# UNITED STATES PATENT AND TRADEMARK OFFICE

APPLICATION NO.	FILING DATE	FIRST NAMED INVENTOR	ATTORNEY DOCKET NO.	CONFIRMATION NO.
10/734,040	12/10/2003	Douglas R. Dole	26978 USA	9198
23307	7590	06/09/2006	EXAMINER	
SYNNESTVEDT & LECHNER, LLP 2600 ARAMARK TOWER 1101 MARKET STREET PHILADELPHIA, PA 191072950			DUNWOODY, AARON M	
			ART UNIT	PAPER NUMBER
			3679

<b>Office Action Summary</b>	<b>Application No.</b>		<b>Applicant(s)</b>	
	10/734,040		DOLE, DOUGLAS R.	
	<b>Examiner</b>		<b>Art Unit</b>	
	Aaron M. Dunwoody		3679

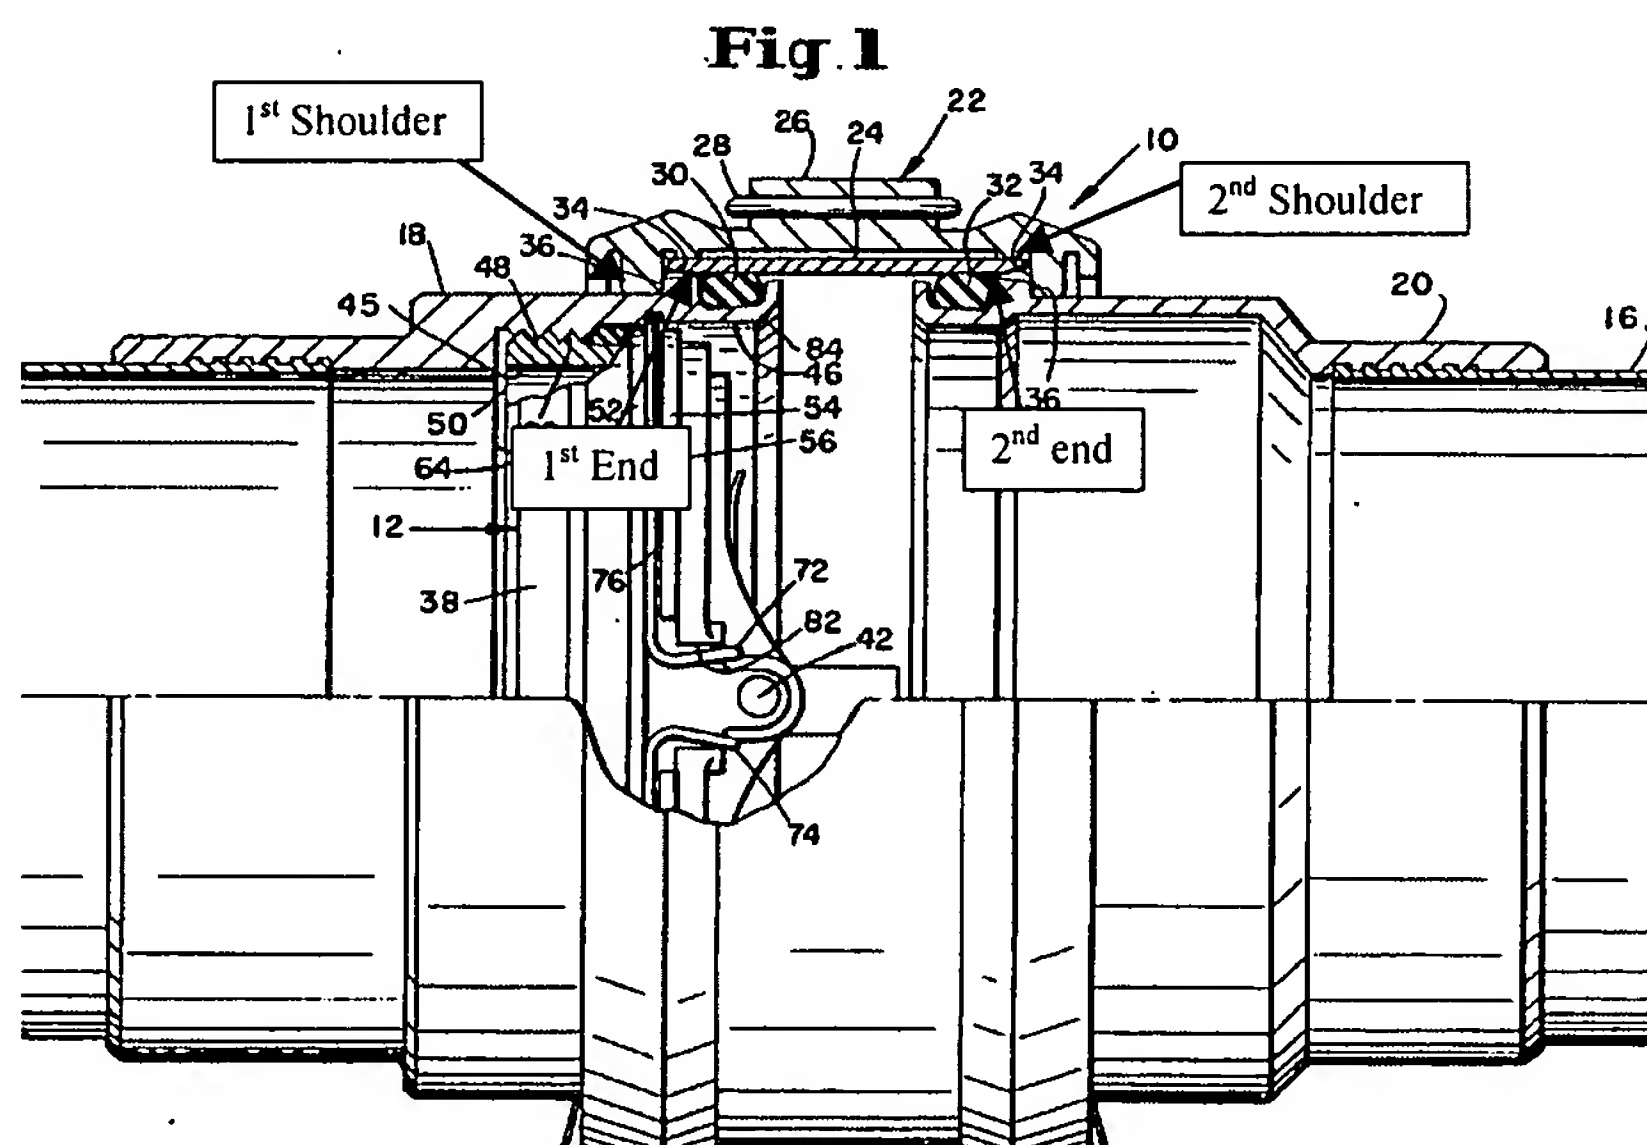
In regards to claim 1, in Figure 1 below, Foster discloses a coupling assembly for flexibly joining pipes (14, 16) to one another end to end and permitting relative axial, torsional and angular deflection between the pipes, the coupling assembly comprising:

a first ring (18) attachable to an end of one of the pipes, the first ring having an outer diameter greater than the pipe and an outwardly facing circumferential groove therein;

a first sealing member (30) positionable within the groove of the first ring and extending circumferentially therearound;

a second ring (20) attachable to an end of another of the pipes, the second ring having an outer diameter greater than the other pipe and an outwardly facing circumferential groove therein;

a second sealing member (32) positionable within the groove of the second ring and extending circumferentially therearound;

a band (24) positionable in overlying relation with and surrounding the first and second rings, the band having an inwardly facing surface sealingly engageable with the first and second sealing members and having a width sufficient to allow a gap between the pipes; and

a housing (22) positionable in overlying relation with and surrounding the rings and radially spaced apart from the band, the housing having a pair of first shoulders positioned in spaced apart relation, each the first shoulders being engageable with one of the rings for limiting axial and angular deflection of one pipe relative to the other, and a pair of second shoulders each said shoulder being positioned on an opposite side of the band, each shoulder being engageable with an edge of the band for maintaining the band engaged with the sealing members.

In regards to claim 10, in Figure 1 above, Foster discloses a coupling flexibly joining pipes to one another end to end and permitting axial, torsional and angular deflection between the pipes, the coupling comprising:

Applicant argues that Foster does not disclose a pair of second shoulders each said shoulder being positioned on an opposite side of the band. The Examiner disagrees. In Figure 1 above, Foster clearly illustrates a pair of second shoulders each said shoulder being positioned on an opposite side of the band, meeting the claim limitation.

**FIG. 4A**

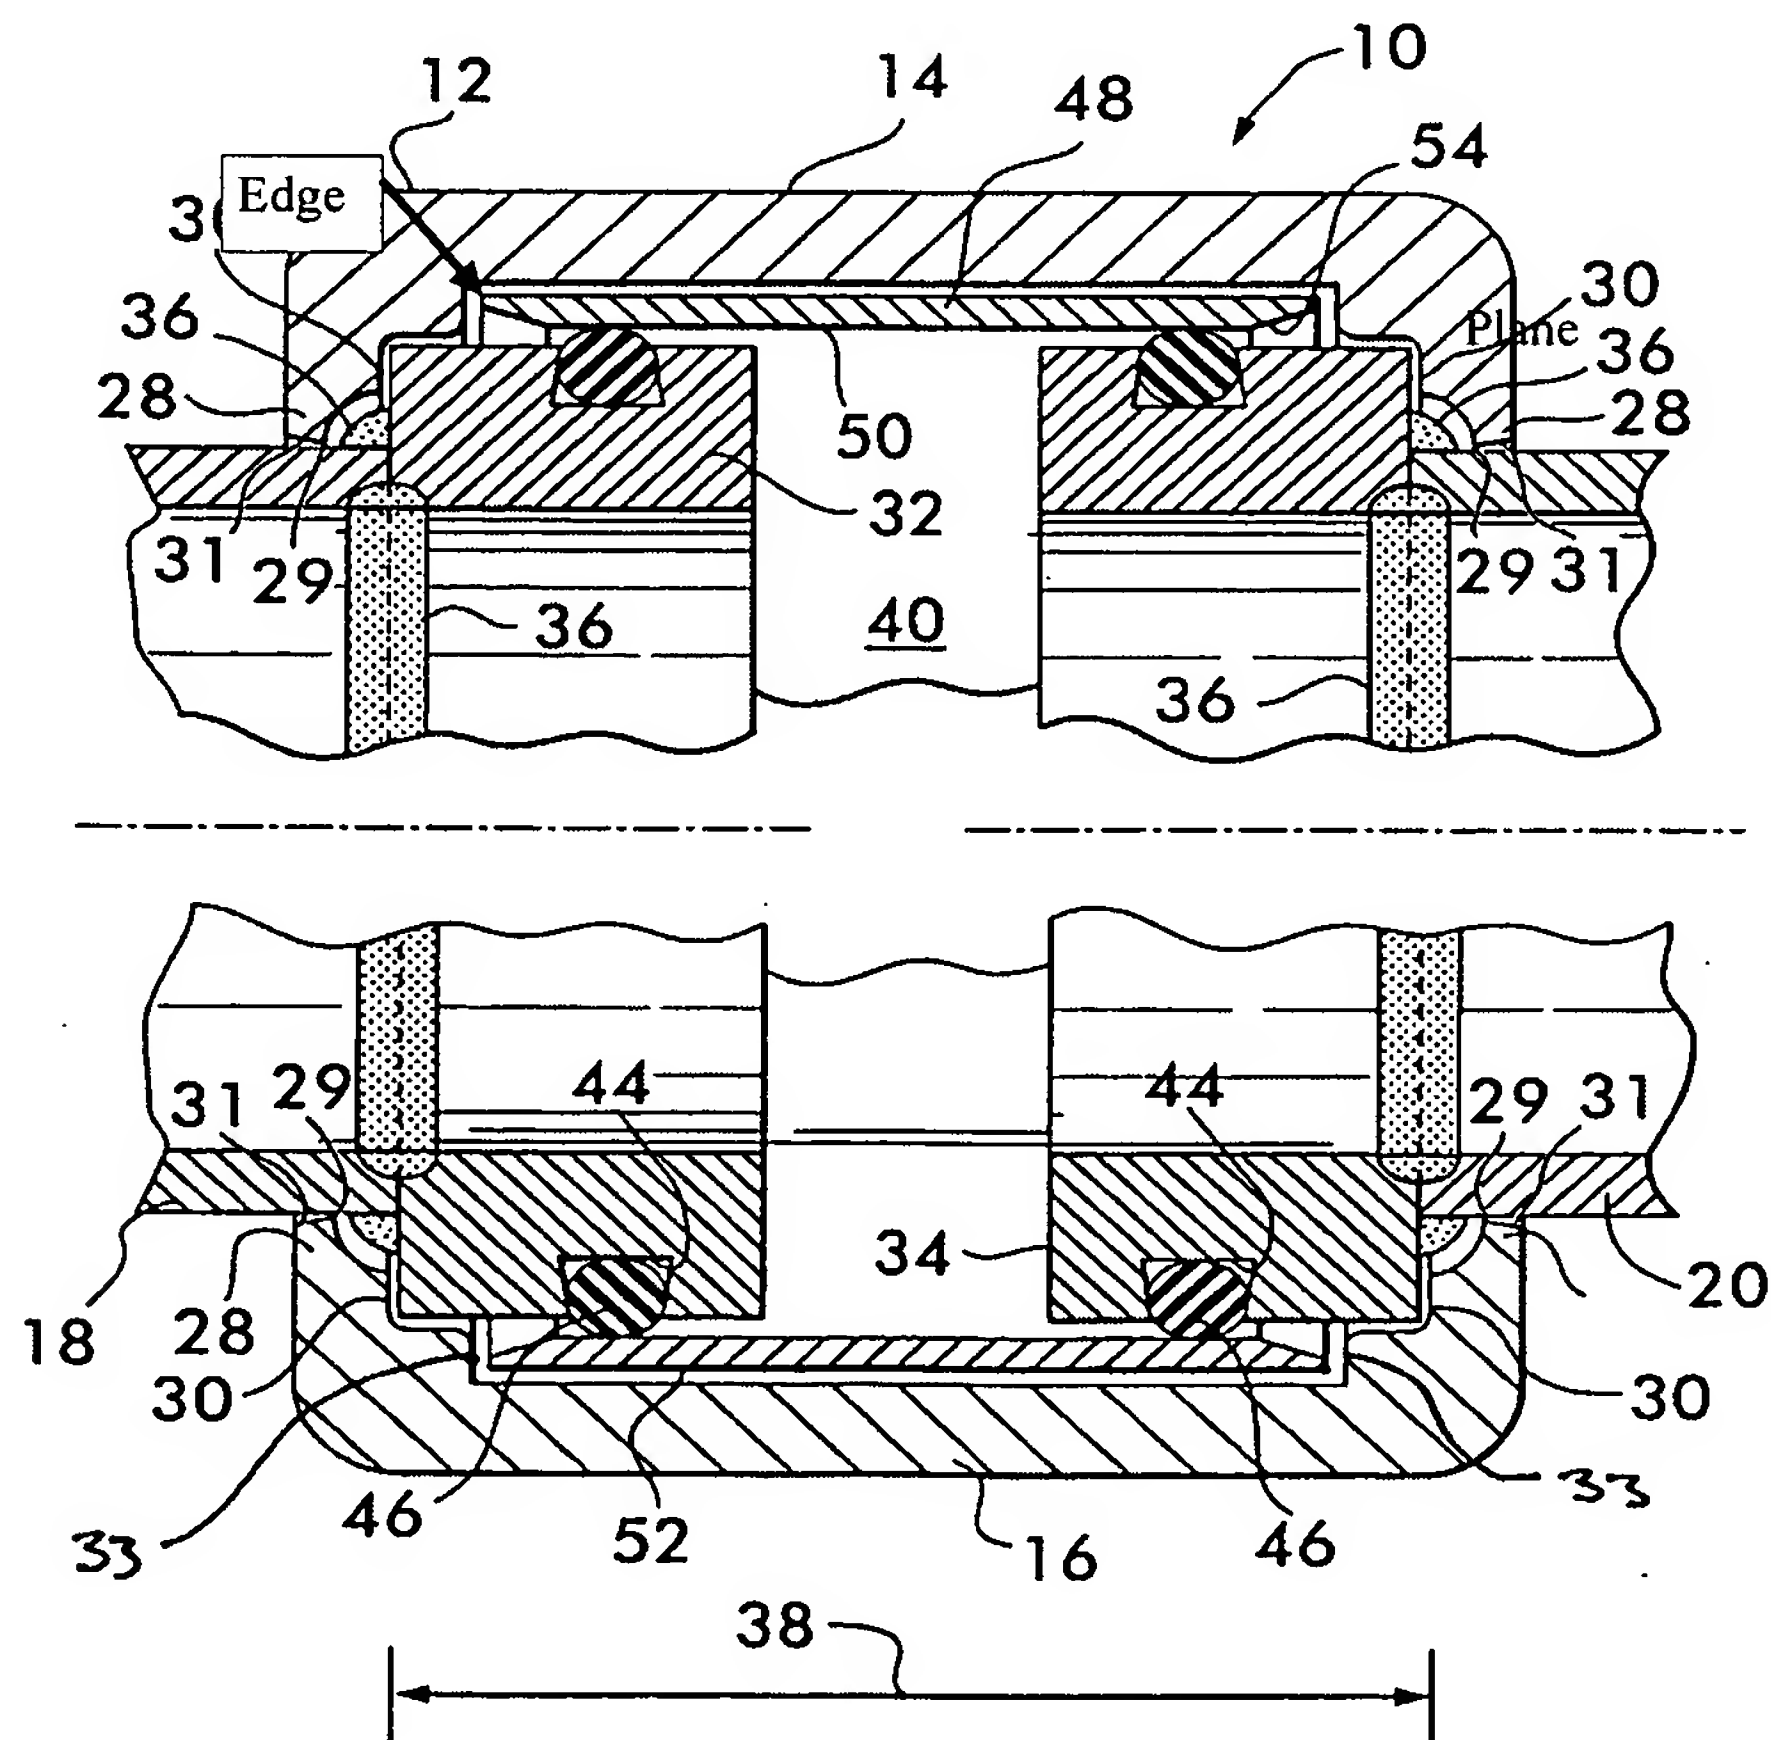
Applicant argues that Foster does not disclose each shoulder being engageable with an edge of the band. The Examiner disagrees. Applicant's Figure 1 discloses each shoulder being engageable with a plane of the band and not an edge (see Figure 4A of instant application).

An edge is:

**3** : a line or line segment that is the intersection of two plane faces (as of a pyramid) or of two planes. [*Merriam-Webster Online Dictionary copyright © 2005 by Merriam-Webster, Incorporated*]

Therefore, Foster discloses each shoulder being engageable with an edge of the band in the same manner that the applicant's "edge" or plane is engagable with each shoulder.
